# Access Compliance Report

## Public Rights-of-Way

Intersection ID: 48634	Main Street: GRANDE_HEIGHTS_DR	Cross Street: DOMINION_CREST_DR	Location: SW
ADA ID: 8B79906C37DA	Ramp Type: Perp	Initial Pass/Fail: Fail	Overall Compliance: No
Severity Score: 8.75			
Codes/Mitigation Info/Possible Solution		Field Measurements/Component Compliance

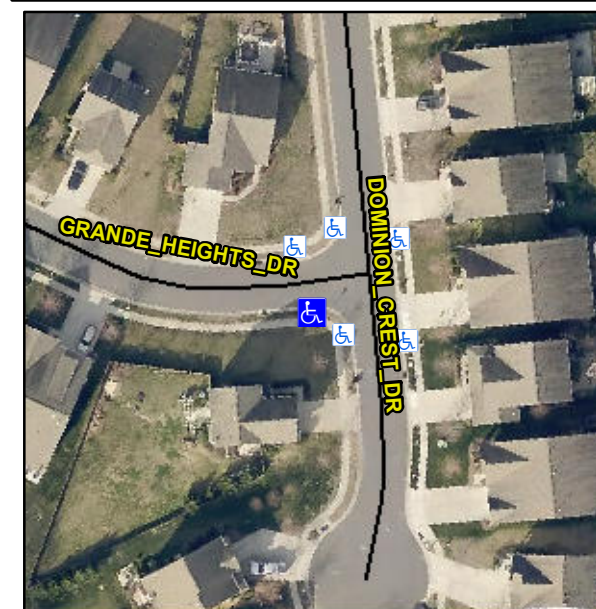
**Not Found, R304.5.1**

Compliance	Description	Data	Compliance	Description	Data
N/A	Ramp Length (in)	44.5	Yes	Ramp Slope (%)	5.3
No	Ramp Width (in)	46.0	Yes	Ramp XSlope (%)	1.2
N/A	Flare Type LT	N/A	N/A	Flare Type RT	N/A
N/A	Flare Slope LT (%)	N/A	N/A	Flare Slope RT (%)	N/A
N/A	Flare Traversable LT?	N/A	N/A	Flare Traversable RT?	N/A
N/A	Landing Length (in)	N/A	N/A	DWS Provided?	N/A
N/A	Landing Width (in)	N/A	N/A	DWS Contrast?	N/A
N/A	Landing Slope (%)	N/A	N/A	DWS Length (in)	N/A
N/A	Landing X Slope (%)	N/A	N/A	DWS Full Width?	N/A
N/A	Landing Curb? (Y/N)	N/A	N/A	DWS Offset (in)	N/A
N/A	Shared Landing?	N/A			
N/A	Gutter Ponding?	N/A	N/A	Gutter Slope (%)	N/A
N/A	Gutter Lip Ht (in)	N/A	N/A	Gutter X Slope (%)	N/A
N/A	Painted X Walk1?	No	N/A	Painted X Walk2?	N/A
	X Walk 1 Direction	To N		X Walk 2 Direction	N/A
N/A	X Walk 1 Width (in)	N/A	N/A	X Walk 2 Width (in)	N/A
	X Walk 1 Slope (%)	0.8		X Walk 2 Slope (%)	N/A
	X Walk 1 X Slope (%)	1.8		X Walk 2 X Slope (%)	N/A

**Remove & Replace Entire Ramp.**
